INDIANA DEPARTMENT OF TRANSPORTATION

APPROVED MINUTES

February 17, 2011 Standards Committee Meeting

RE: Minutes for the February 17, 2011 Standards Committee Meeting

601-MPPG-03 MEDIAN PIER PROTECTION GUARDRAIL

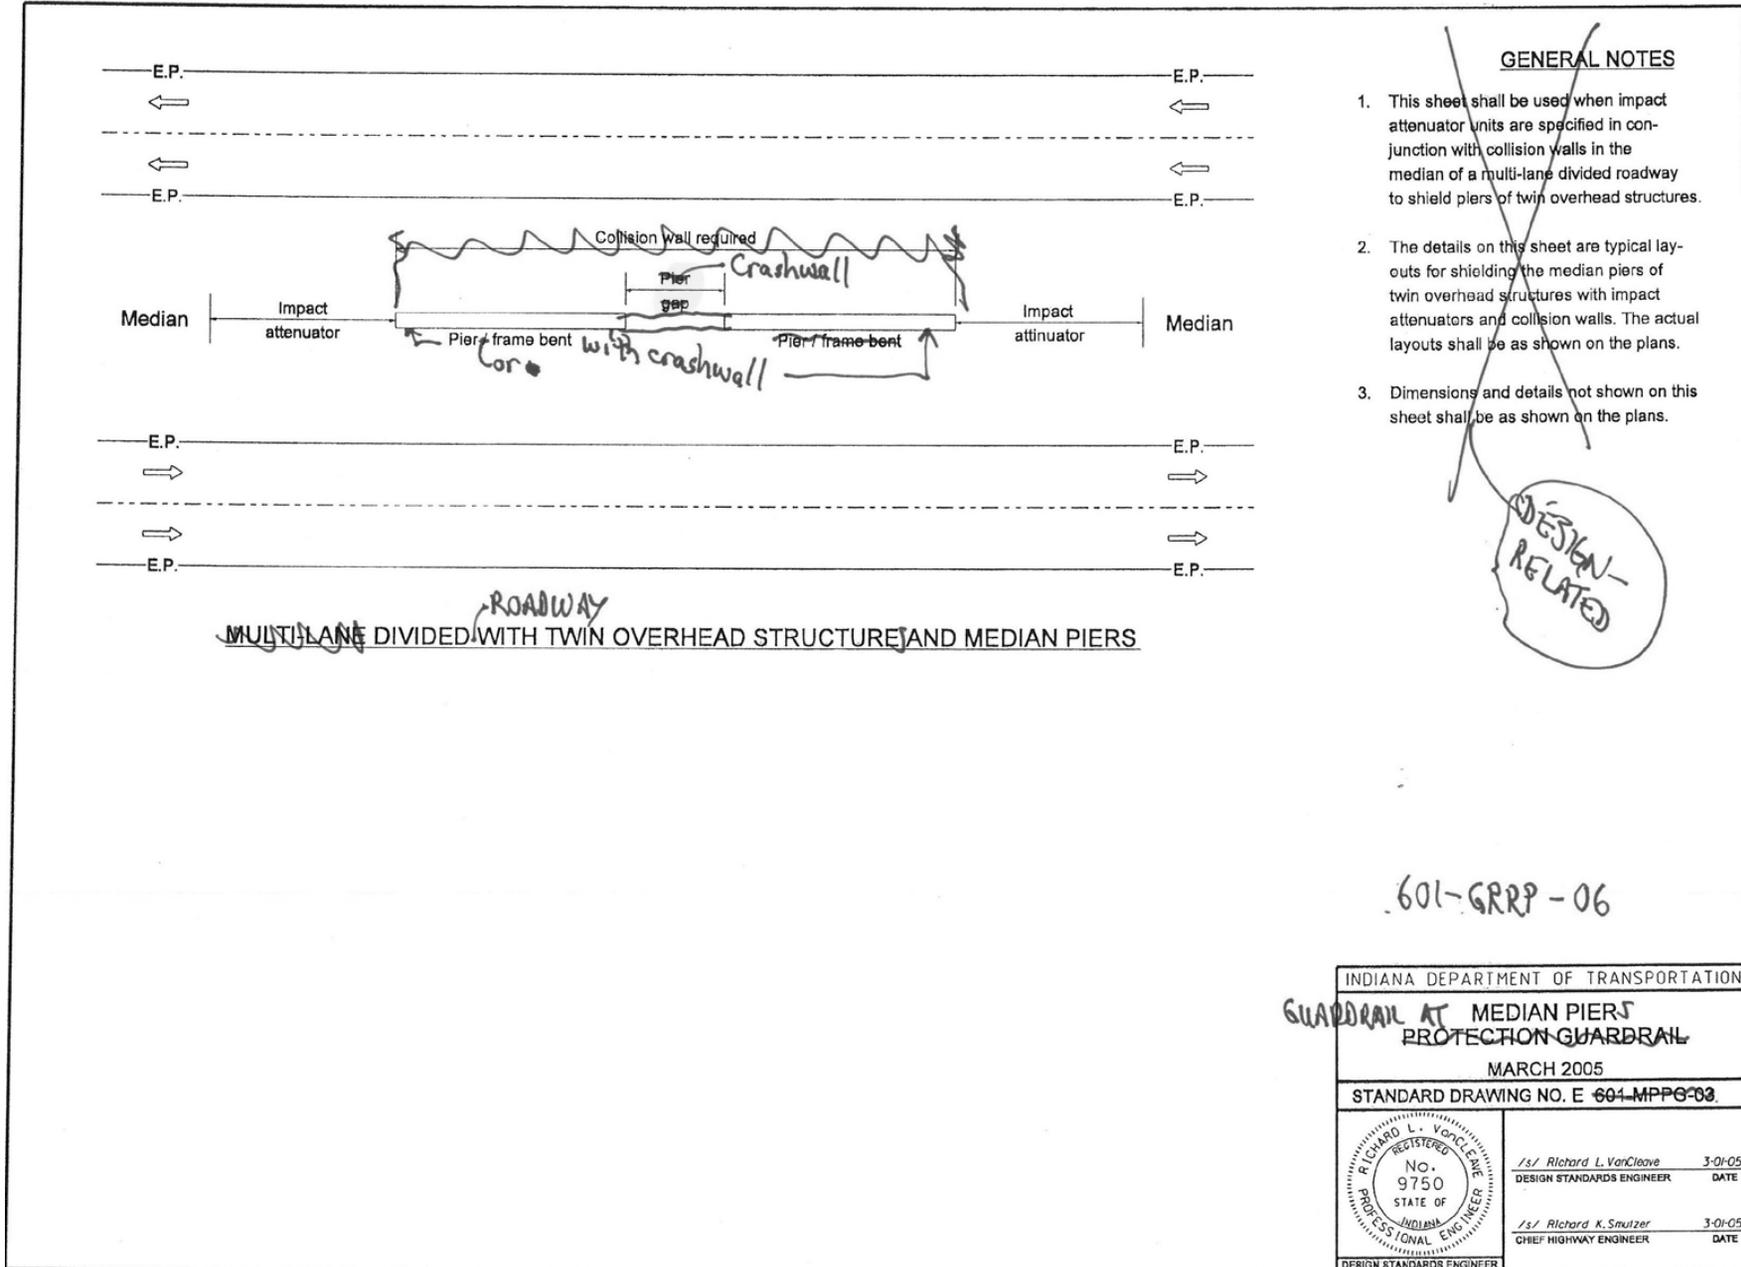
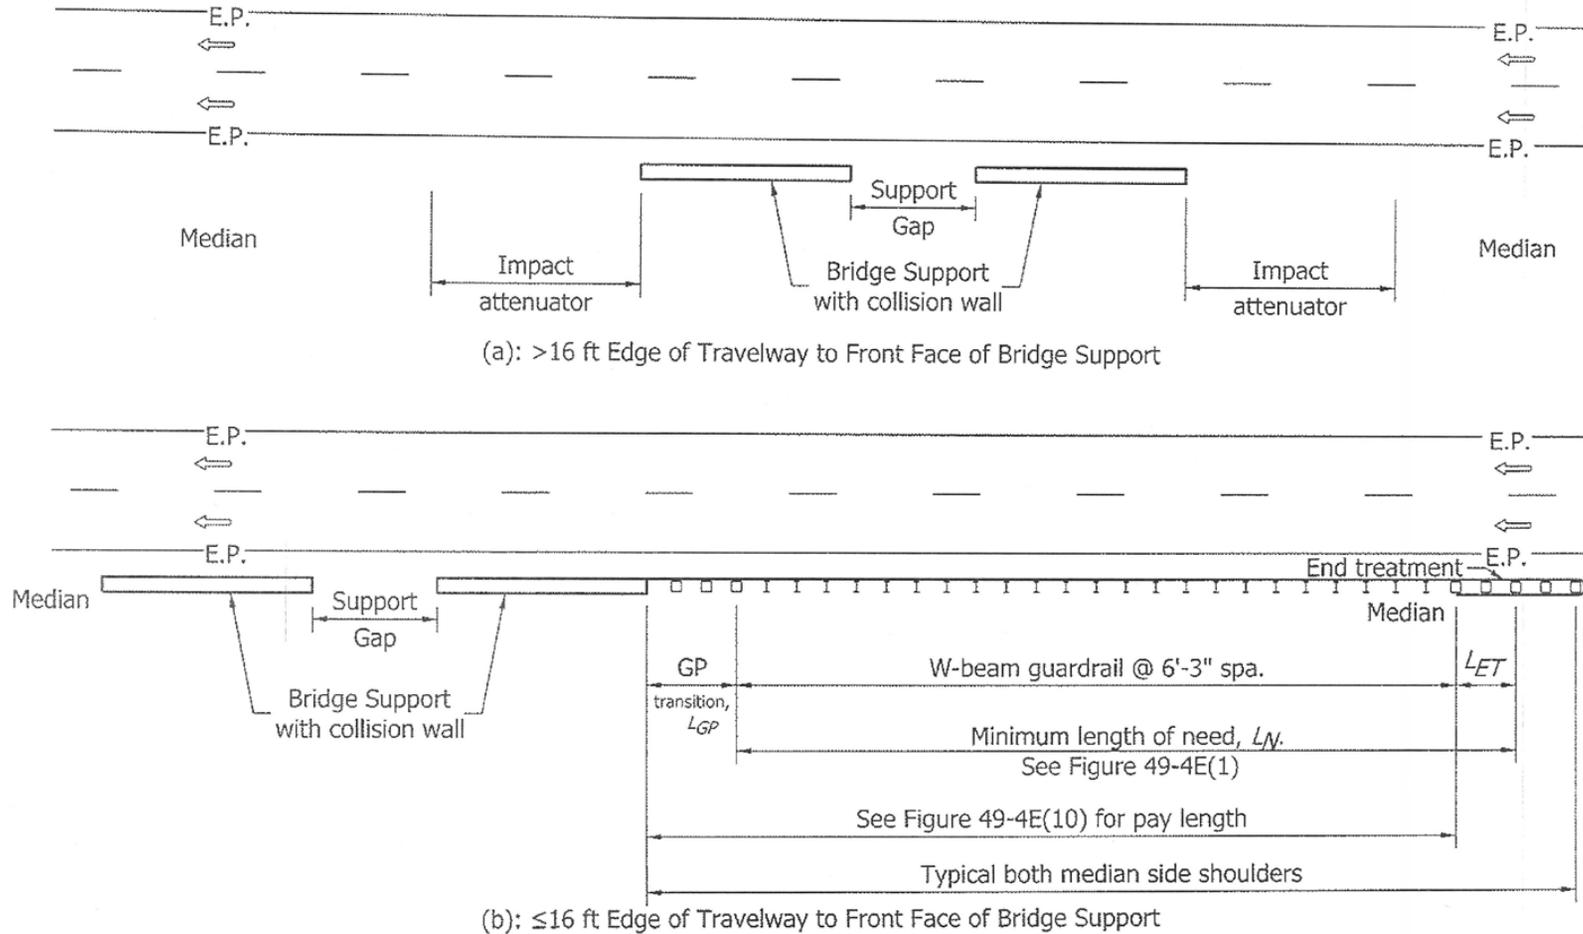
BACKUP: IDM FIGURE 49-4E(9) GUARDRAIL CONFIGURATION FOR BRIDGE SUPPORT INSIDE CLEAR ZONE, ONE-WAY ROADWAY, TWIN OVERHEAD STRUCTURE, MEDIAN SHOULDER (DRAFT)

Guardrail to Pier Clearance

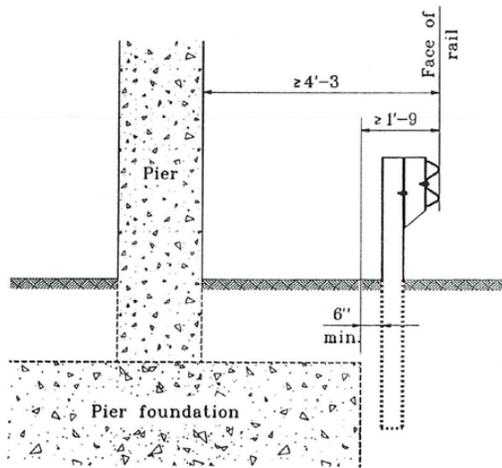
DELETE DWG.
 DUPLICATES EXISTING
 601-MPPG-02.
